# THE URBAN WILDLANDS GROUP, INC.

November 13, 2004

### **Re: Staff Report and Recommendation on Consistency Certification and Consistency Determination (Los Angeles World Airports/Federal Aviation Administration)**

**Figure 1. Location of new navigational aids in the El Segundo dunes. The aids would be located in Los Angeles coastal prairie (prairie/grassland), backdune, and foredune habitat. The mitigation site is only foredune habitat.**

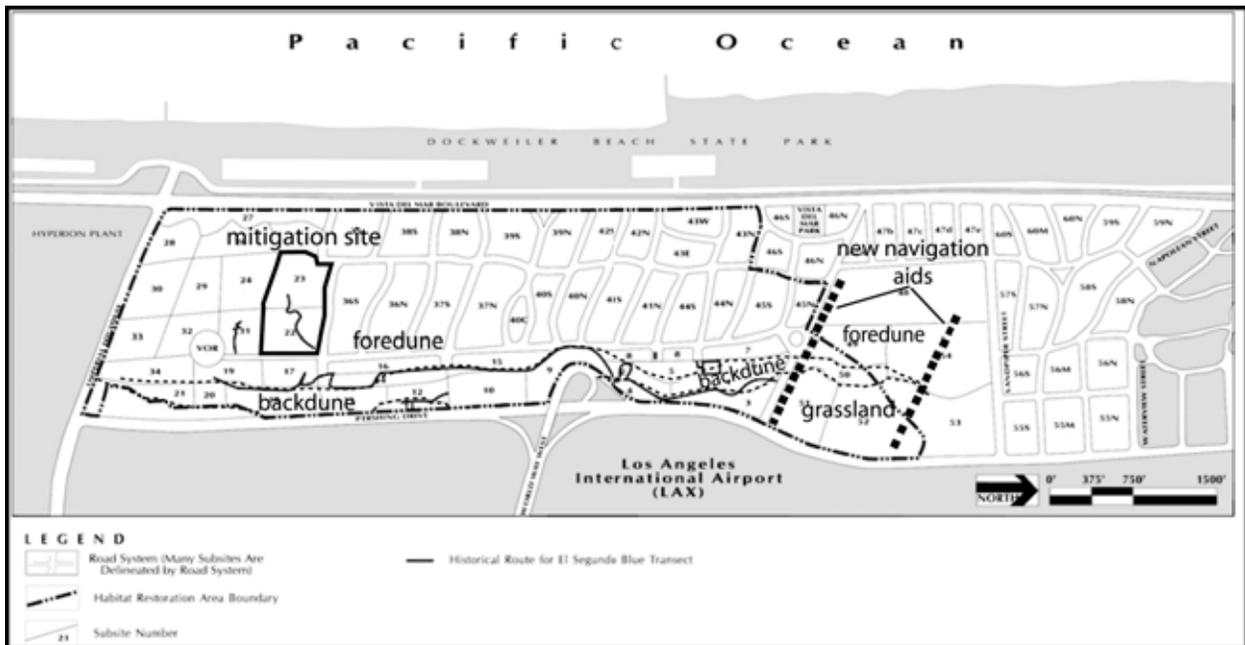
- The restoration plan proposes mitigating for impacts to prairie/grassland and backdune habitat by restoring foredune habitat.** Our research has shown, as has that of LAWA's consultants, that El Segundo blue butterfly density is highest on the backdune slope. Many of the navigational aids will affect backdune and prairie/grassland areas, but the mitigation sites (22 and 23) are foredune habitats and therefore out-of-kind mitigation for many of the impacts (Figure 1). The foredune mitigation sites were surveyed from 1984 to 1994 and consistently supported a below-average number of butterflies, except during a high rainfall year. During many years, foredune sites support 90% fewer butterflies than good backdune sites, so a higher mitigation ratio would be advisable, in addition to in-kind mitigation.

- The geographic configuration of the navigational aids would increase "edge" area within the dune system** (Figure 1). Increased edge area is as deleterious as direct habitat

loss for survival of the rare species of the El Segundo dunes. According to the CEQA analysis for the project, four lights will be removed from the butterfly preserve, while eleven new lights will be installed. These new lights would be installed right through the only existing remnant of Los Angeles coastal prairie. Outside the preserve, eight structures would be removed while twelve new structures would be installed. Our previous analysis revealed that over 1,300 feet of new habitat edges will be introduced into the dunes. No analysis or mitigation of these edge effects is apparent in the proposal or Staff Report.
